# OVERLOOK at OXBOW

**To:** Cheryl Somerfeldt, Case Planner  
**From:** Jim Strozier, Consensus Planning, Inc.   
**Date:** February 6, 2019  
**Re:** Overlook at Oxbow: Project # 2018-00140

APPLICANT RESPONSE TO UPDATED COMMENTS 2/6/2019

**Re:** Project #: 2018-001402, SI-2018-00171 – Site Plan EPC

## SENSITIVE AREAS

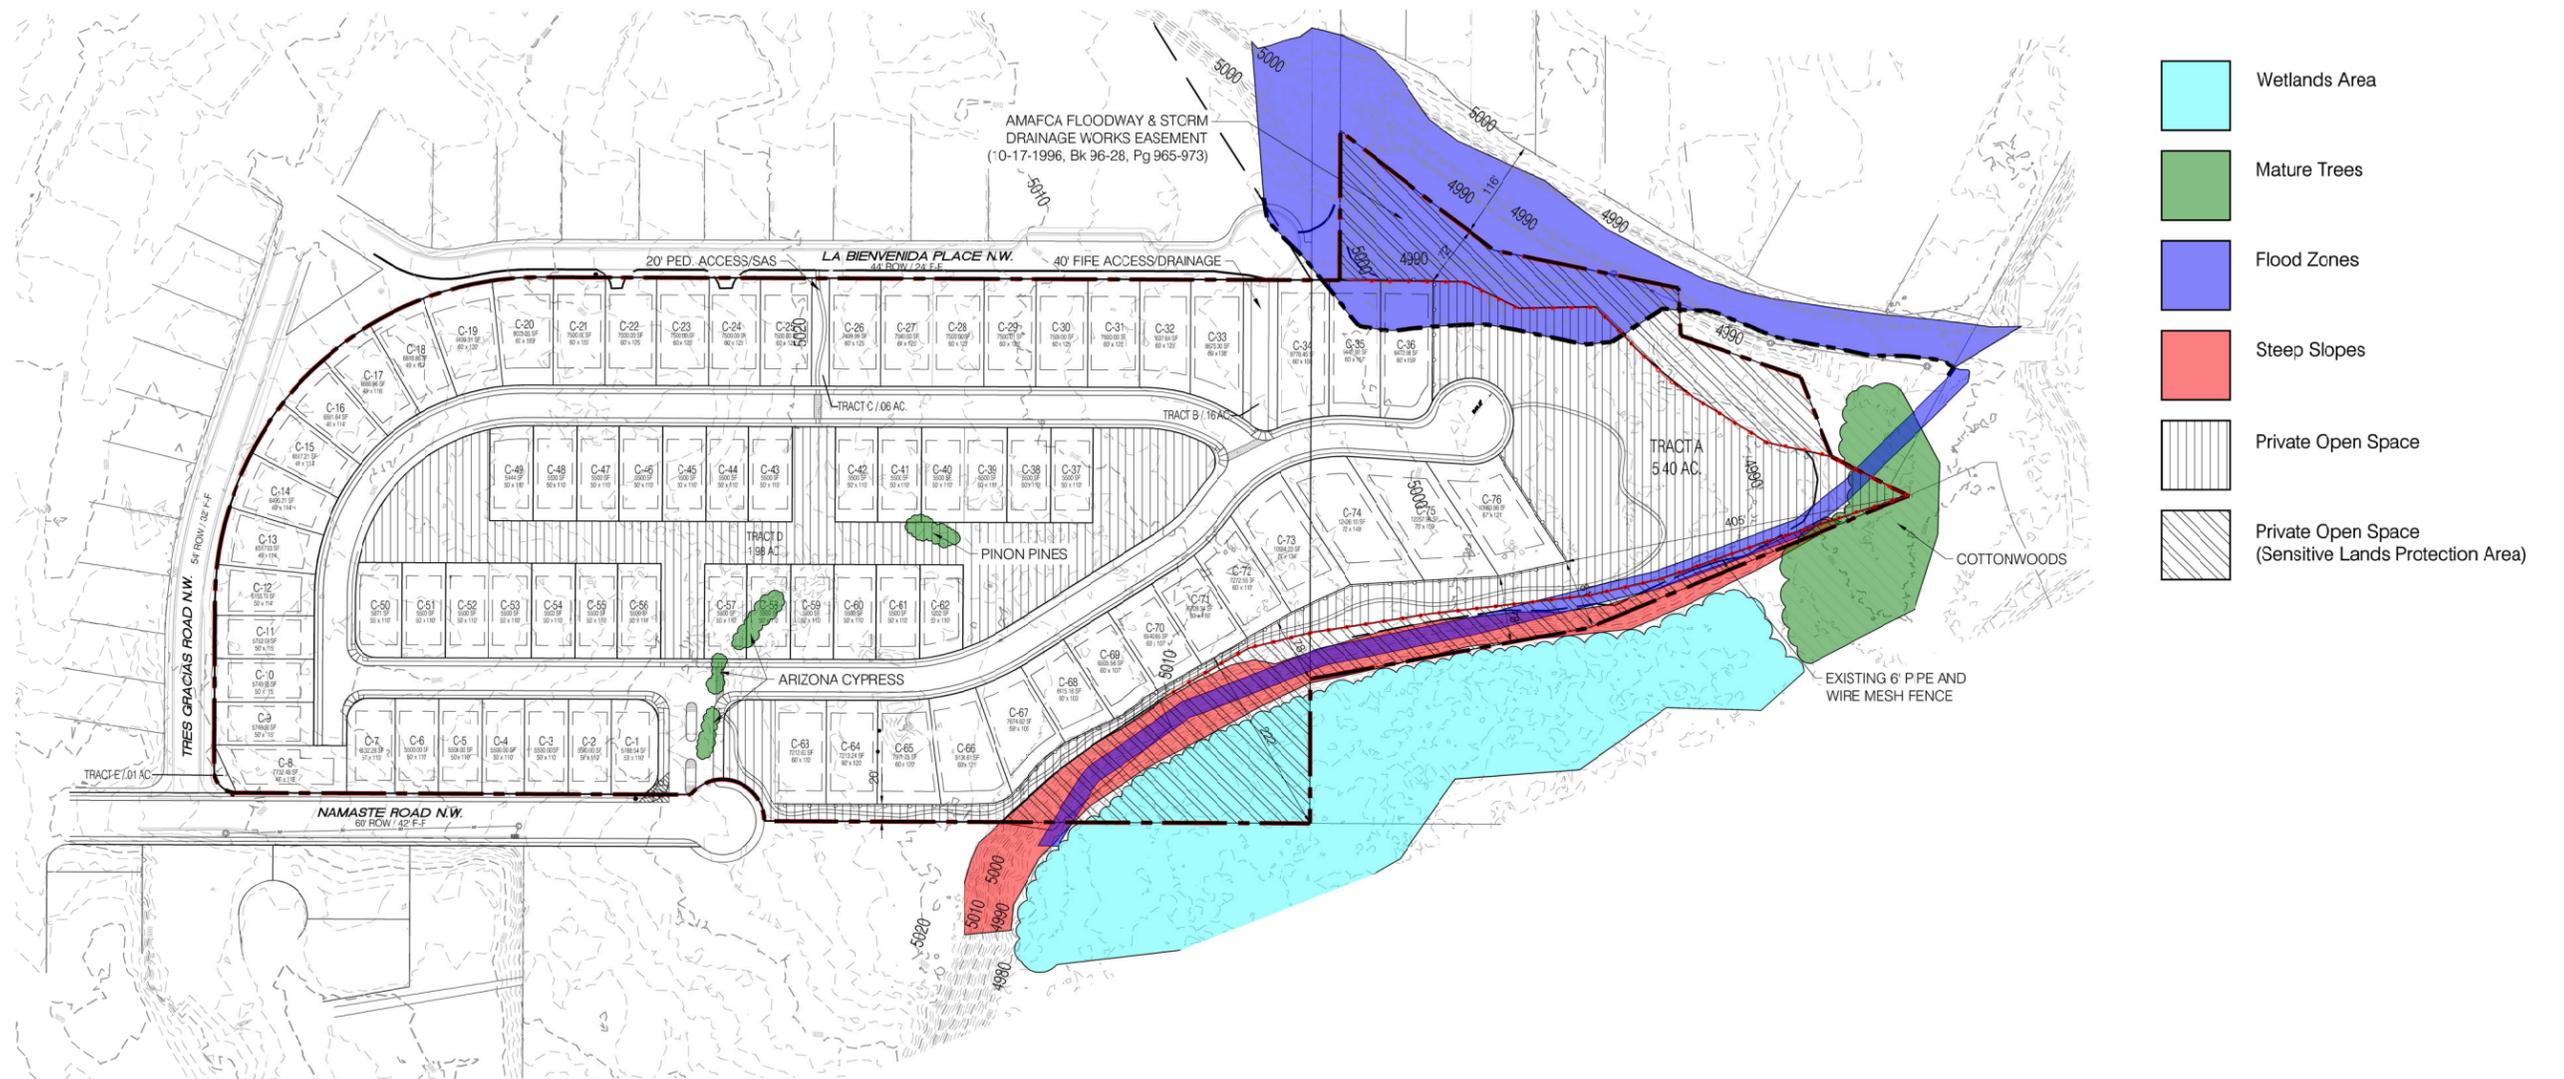
4. Will there be an updated project letter submitted?  
*Yes, it is being submitted separately.*
5. Have you contacted the City Forester to set up a meeting to review the existing mature trees?  
*A meeting was held today at 10 am with the City Forester. A summary of that meeting will be provided when available. The Sensitive Lands Diagram has been modified based on the meeting.*

6. Is there an updated Sensitive Lands Diagram?  
*Yes, it is being submitted with this memo.*

- 2) All floodplains need to be shown on the plat and site plan.  
*The floodplain information has been added to the Site Plan and included on the Sensitive Lands Analysis map.*

OVERLOOK at OXBOW SITE PLAN - EPC - REQUIRED INFORMATION

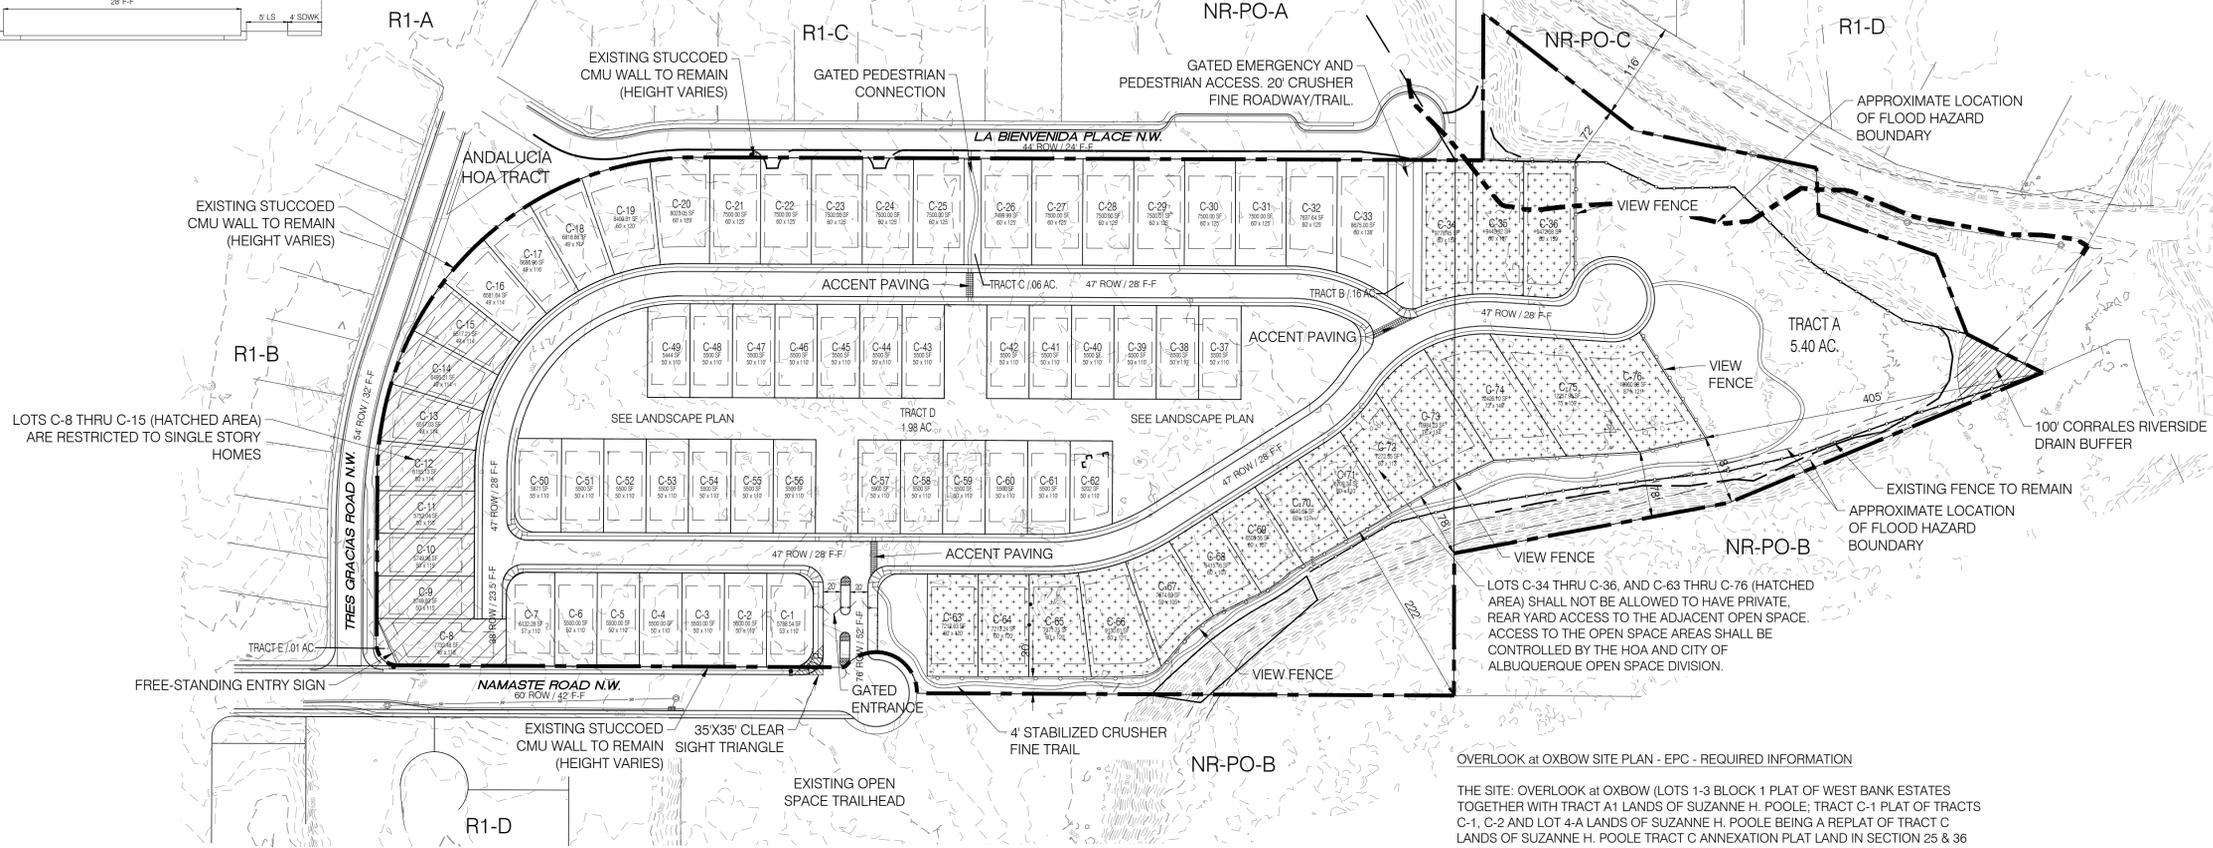
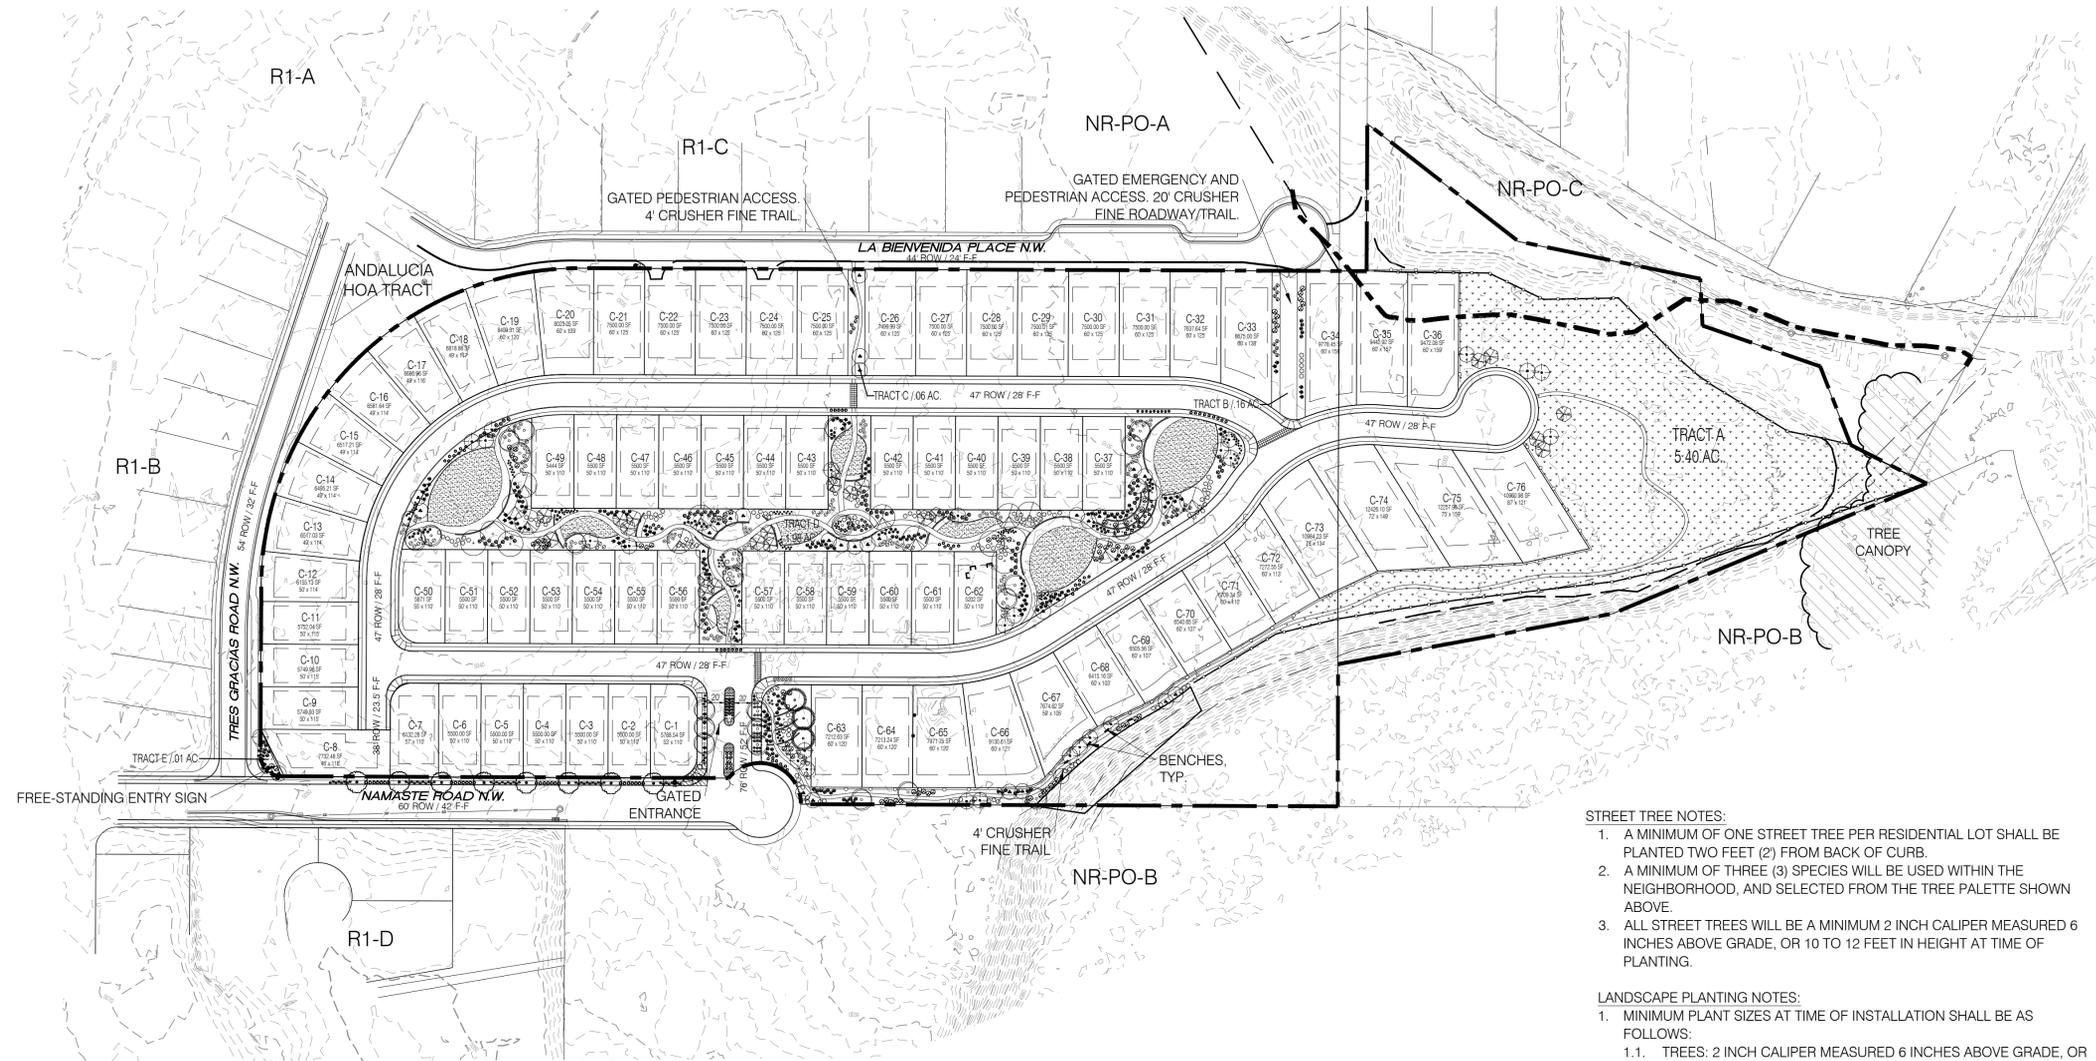
4. The Site Plan shall note any Variance – DRB that has been granted/approved for IDO Section 14-16-5-3(E)(2)(a) on the Site Plan. **Site Plan, Sheet 1, has been revised to add this information as General Note 2.**

5. The Site Plan shall clearly note the setbacks and building envelopes for all cluster lots, including R-A zone district setbacks at the perimeter of each cluster per IDO Section 14-16-4-3(B)(2)(b). **Site Plan, Sheet 1, has included setbacks for all lots.**

- Developer is responsible for permanent improvements to the transportation facilities adjacent to the proposed development site plan, as required by the Development Review Board (DRB). *Site Plan, Sheet 1, General Note 3.*
- Infrastructure and/or ROW dedications may be required at DRB. *Site Plan, Sheet 1, General Note 3.*
- All work within the public ROW must be constructed under a COA Work Order. *Agreed.*
- The following comments need to be addressed prior to DRB:

Show the clear sight triangle and add the following note to the plan: "Landscaping and signage will not interfere with clear sight requirements. Therefore, signs, walls, trees,

- Per the 2040 Long Range Bikeway System Map there is a bicycle route proposed along Namaste Road and at La Bienvenida Pl. adjacent the west side of subject property. **Site Plan, Sheet 1, Pedestrian and Vehicular Ingress and Egress, Bullet #6.**

and shrubbery between 3 and 8 feet tall (as measured from the gutter pan) will not be acceptable in the clear sight triangle. **Site Plan, Sheet 1, General Note 4.**

## LANDSCAPE PLAN

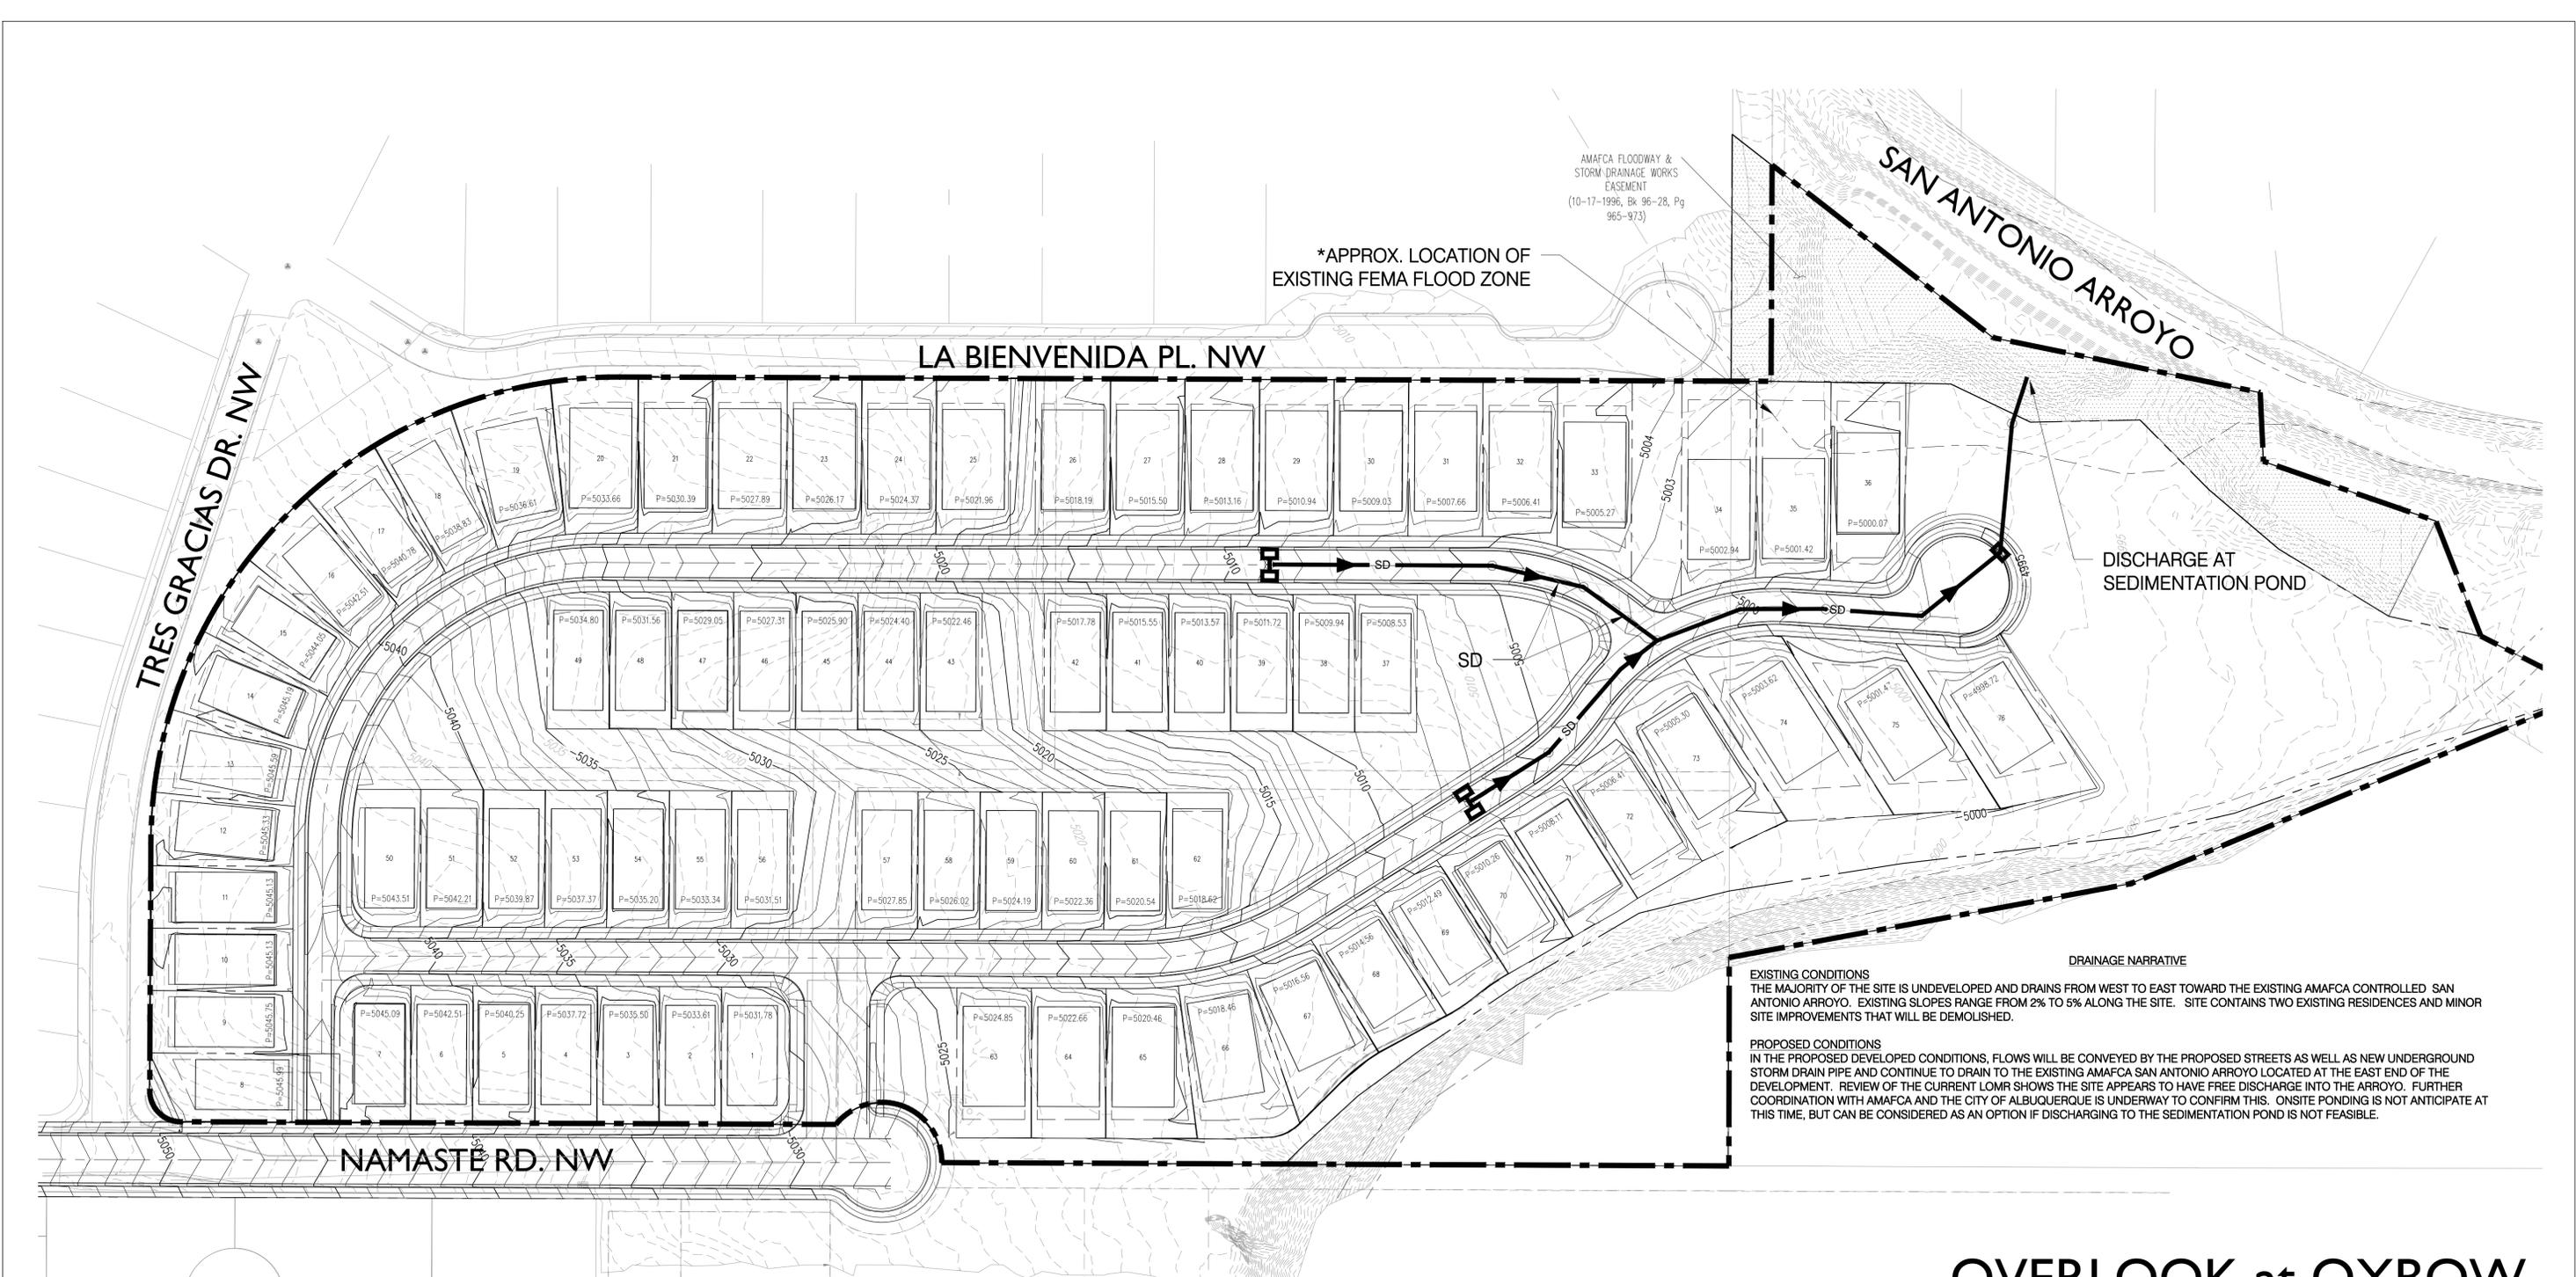
3. The Site Plan shall eliminate turf in all on-site common open space and shall retain the sense of the natural features and vegetation, including reconstruction and revegetation to a natural setting to the maximum extent practicable (ABC Comp Plan Policy 10.1.4 and IDO Sections 14-16-5-2(H)(2)(a)1 and 14-16-3-4(C)(5)(b)). **Landscape Plan, Sheet 2 has been revised to reconfigure the open space to provide a contiguous open space network and trail system. As a part of this revision the turf areas have been eliminated. The landscape plan has been revised to show native grass areas, including buffalo and blue grama grasses.**

6. The Site Plan shall ensure that all on-site, common open space areas are partially visible from a public right-of-way per IDO Section 14-16-4-3(B)(2)(d)3. **Landscape Plan, Sheet 2 has been revised to reconfigure the open space to provide a contiguous open space network and trail system. As a part of this revision the open space is visible from both the end of Namaste and La Bienvenida.**

7. The Site Plan shall remove all references to structures from the on-site, common open space areas unless they can be shown necessary for operation and maintenance per IDO Section 14-16-4-3(B)(2)(d)4. *Landscape Plan, Sheet 2 has been revised to reconfigure the open space to provide a contiguous open space network and trail system. As a part of this revision the structures have been eliminated.*

8. The Site Plan shall clearly note how the maintenance of each on-site, common open space(s) for each cluster will be the responsibility of each group of corresponding cluster lots per IDO Sections 14-16-4-3(B)(2)e and f. *Landscape Plan, Sheet 2, Maintenance Note.*
